DATE 7/18/89 SUBJECT GRN-07-89-12-07-00 SHEET NO. 1 of 41

THIS ANALYSIS IS BEING CONDUCTED TO ANSWER SPECIFIC QUESTIONS AS PART OF A CONDITIONAL CONCURRENCE AGREEMENT BETWEEN THE DOE AND NRC ON THE GREEN RIVER REMEDIAL ACTION IN UTAH. THE FOLLOWING ARE THE SPECIFIC AGREEMENT ITEMS (NRC, 1989):

ADDITIONAL INFORMATION AND JUSTIFICATION NEEDED IN GREEN RIVER FINAL REMEDIAL ACTION PLAN

DISSOLVED BERYLLIUM CONCENTRATIONS

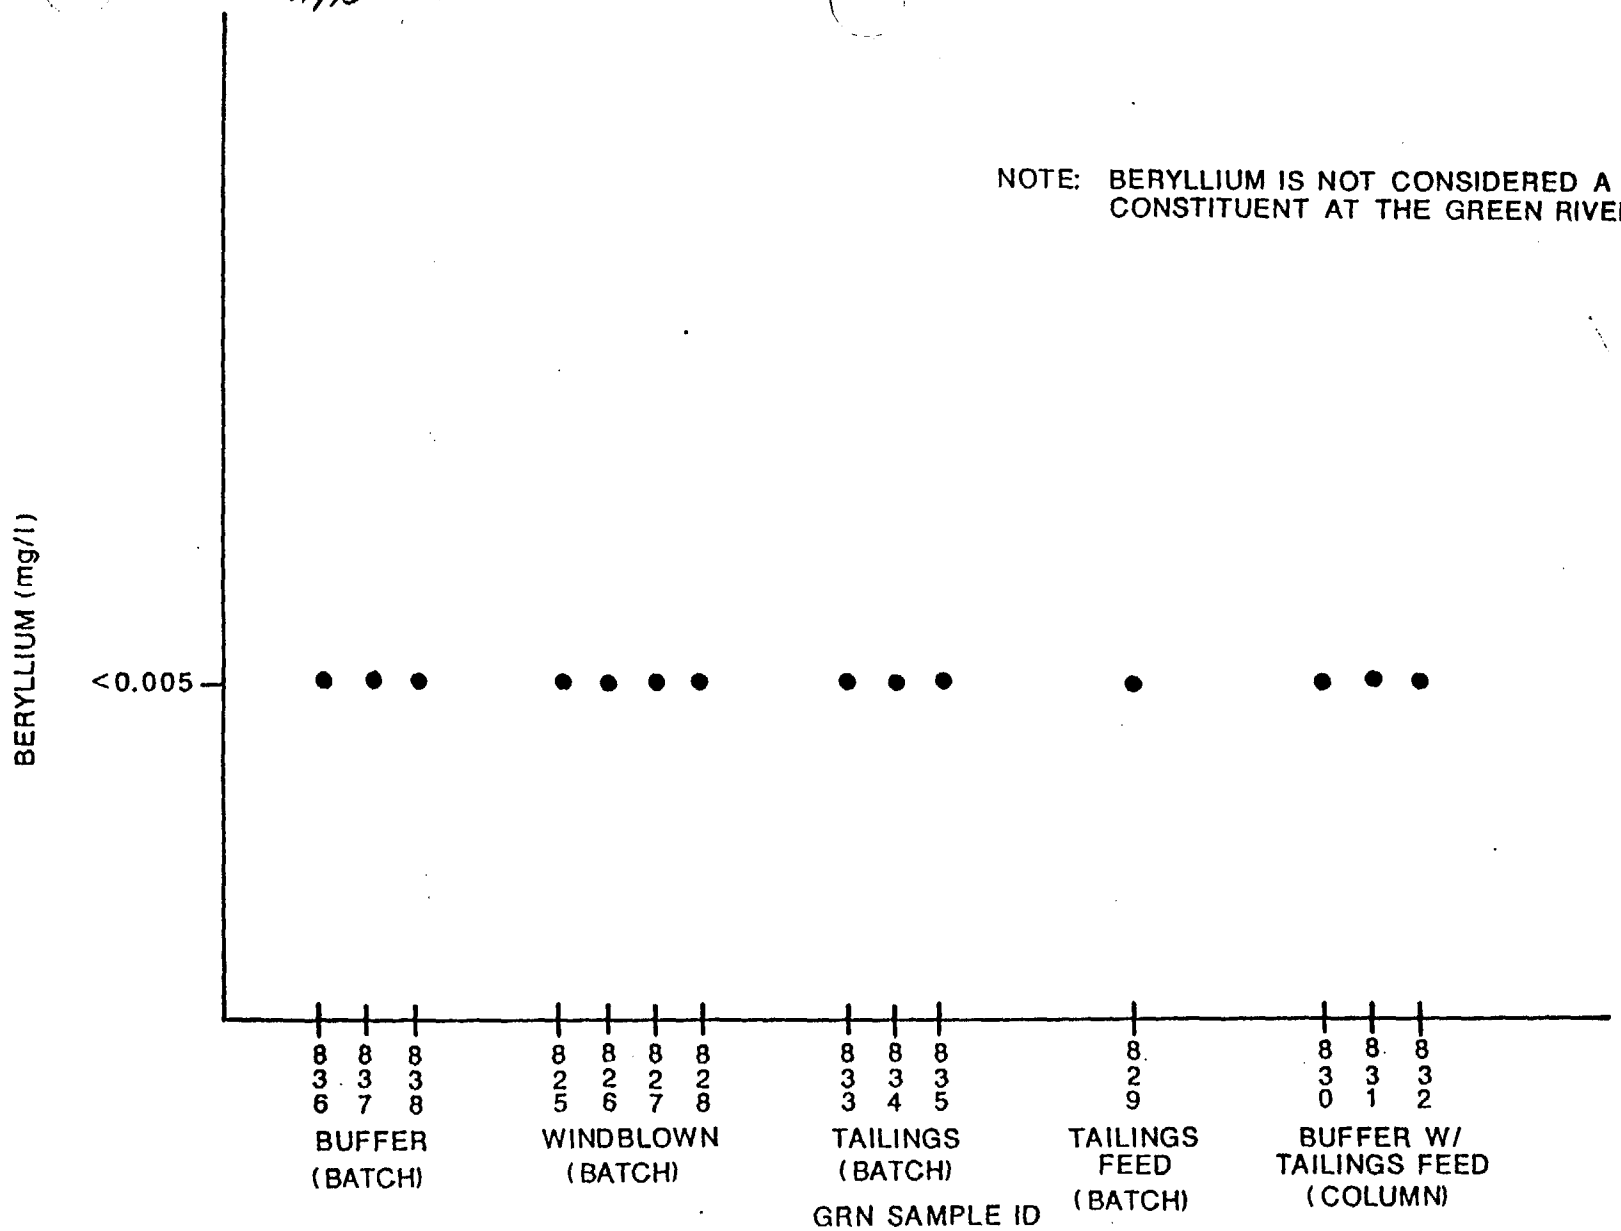
② NEITHER BERYLLIUM NOR THALLIUM ARE PRESENT AT THE GREEN RIVER SITE AND SHOULD NOT BE ADDED TO THE LIST OF HAZARDOUS CONSTITUENTS.

In response to Item No. 7, neither beryllium nor thallium were detected in the tailings or windblown batch solutions.

MOISTURE CONTENT/DENSITY TEST LOCATIONS

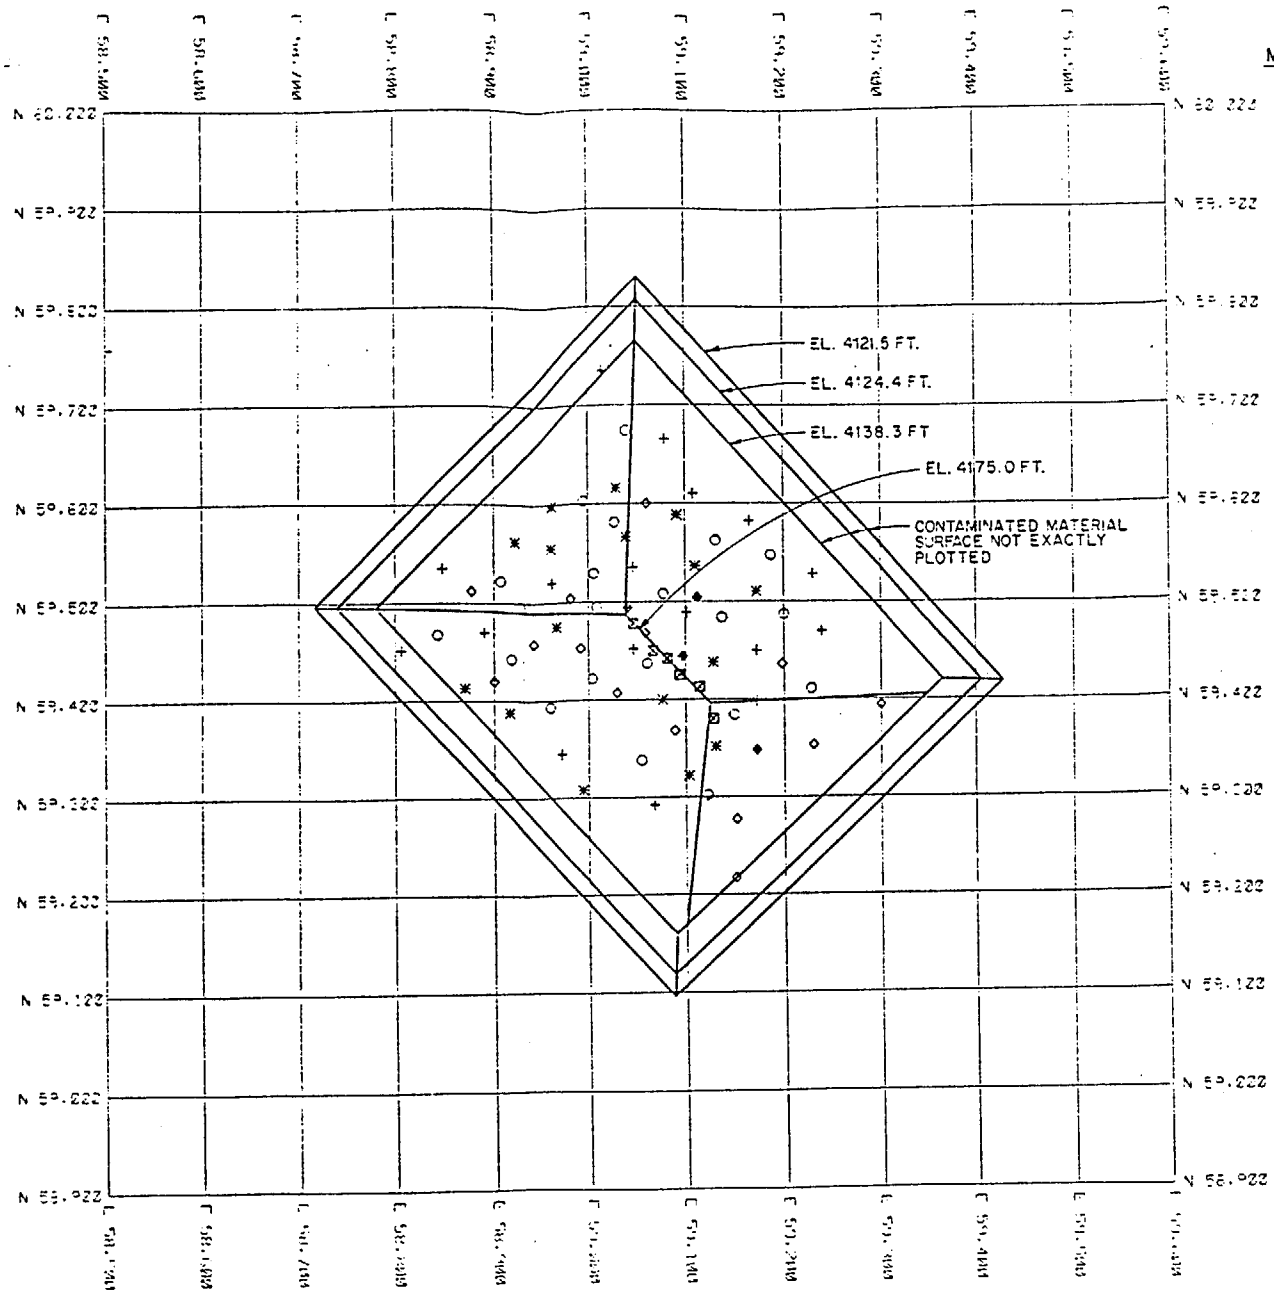
- **Information on all density and moisture content tests performed to verify the placement density and moisture contents of the contaminated materials placed in the disposal cell. The location of the tests should be shown on a plan of the cell along with the elevation of the test location. This is the areal and vertical control information for the test locations.**

Dry density, percentage compaction, moisture content and moisture content relative to optimum moisture content of all density determinations performed on contaminated materials are presented in Tables 3A and 3B. Coordinates and elevations of the compaction determinations are presented in Tables 4A and 4B and plotted on Figure 1. Based on the scatter of test locations on Figure 1, it
